HISTORIC AND DESIGN REVIEW COMMISSION

HDRC CASE NO: 2018-207
ADDRESS: 410 N OLIVE ST
LEGAL DESCRIPTION: NCB 578 BLK D LOT 2
ZONING: RM-4
CITY COUNCIL DIST.: 2
DISTRICT: Dignowity Hill Historic District
APPLICANT: Jenny Hernandez
OWNER: Jason Beltran
TYPE OF WORK: New Construction - Conceptual
APPLICATION RECEIVED: April 30, 2018
60-DAY REVIEW: June 29, 2018
REQUEST:

The applicant is requesting conceptual approval to construct a single family residential structure on the vacant lot at 410 N Olive.

FLOOR PLAN

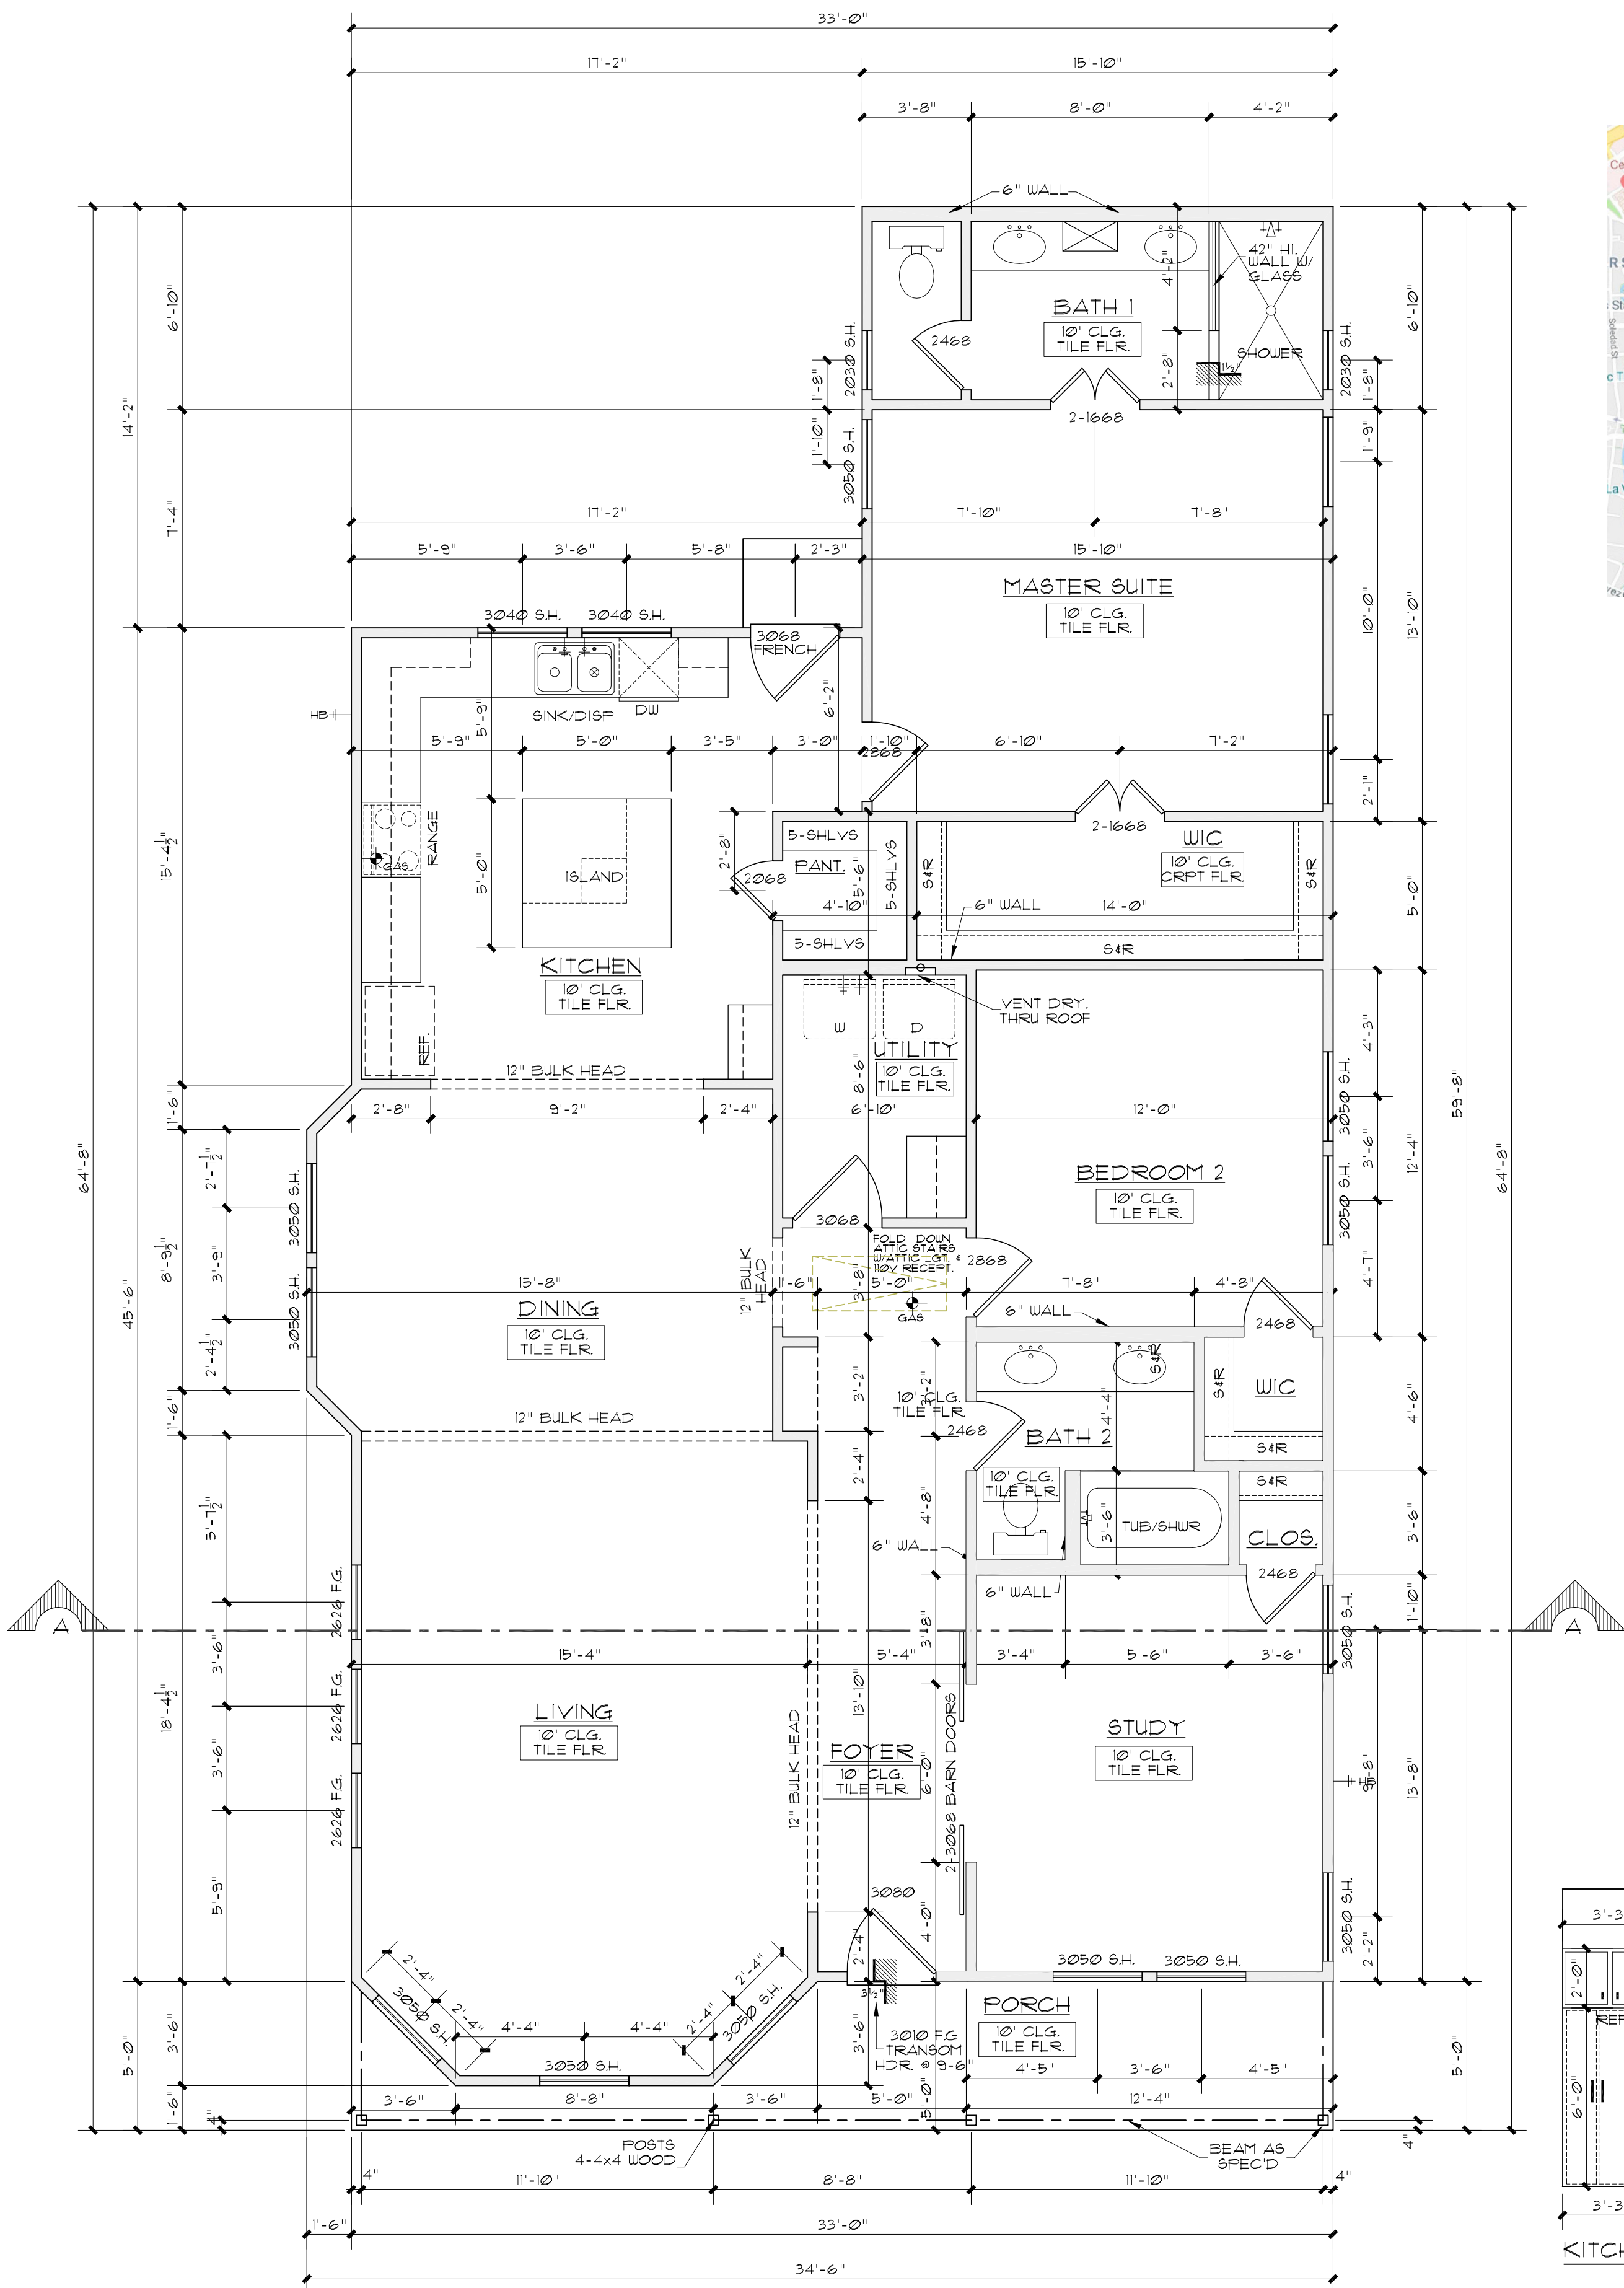
- iv. That the primary wall of the structure should be shifted toward the rear to produce a true "L-plan", rather than feature a window bay that shares a wall plane with both the porch and front façade of the house as noted in finding j.

FRONT ELEVATION

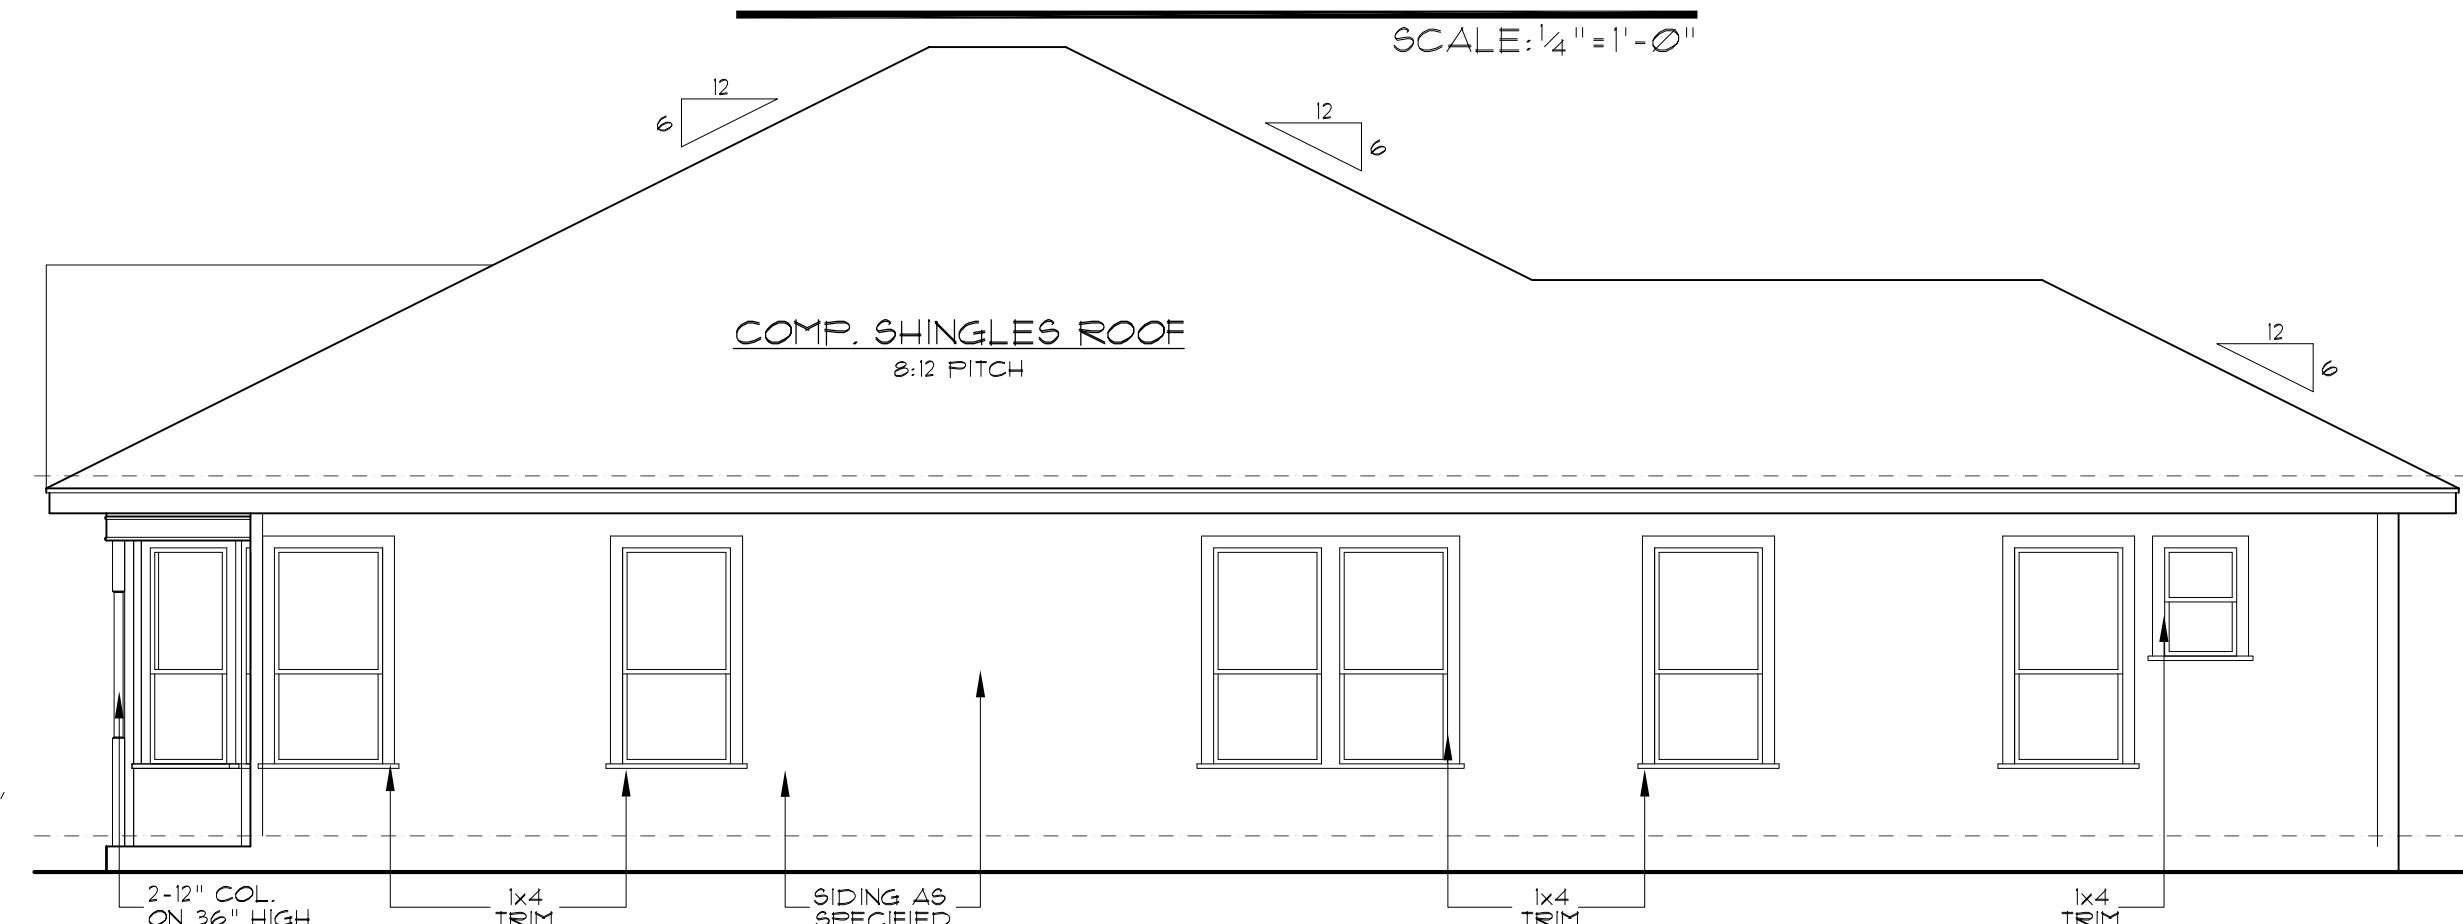
- h. **WINDOW & DOOR OPENINGS** – Per the Guidelines for New Construction 2.C.i., window and door openings with similar proportions of wall to window space as typical with nearby historic facades should be incorporated into new construction. The applicant has proposed window openings that feature sizes and locations comparable to those found historically in the district. Double windows should feature a mullion of at least six inches between openings. A transom window should be featured above the front entrance door.

- i. **WINDOW BAY (Fenestration)** – The applicant has proposed a window bay to feature a total of three windows, with one window centered under the gable. This is appropriate.

- j. **FRONT FAÇADE MASSING** – The applicant has proposed front façade massing that includes a window bay that is covered by a gabled roof which features the same façade plane as the structure's primary roof (hipped). The historic profile of a window bay includes an extension beyond the profile and massing of the structure's primary roof and porch. Staff finds that the primary wall of the structure should be shifted toward the rear to produce a true "L-plan", rather than feature a window bay that shares a wall plane with both the porch and front façade of the house. While the applicant has modified this from previous submittals, staff finds that the proposed front façade depth is not consistent with historic examples found in the district.

- 6inches in between window openings
- transom window above door
- middle window at center of gable
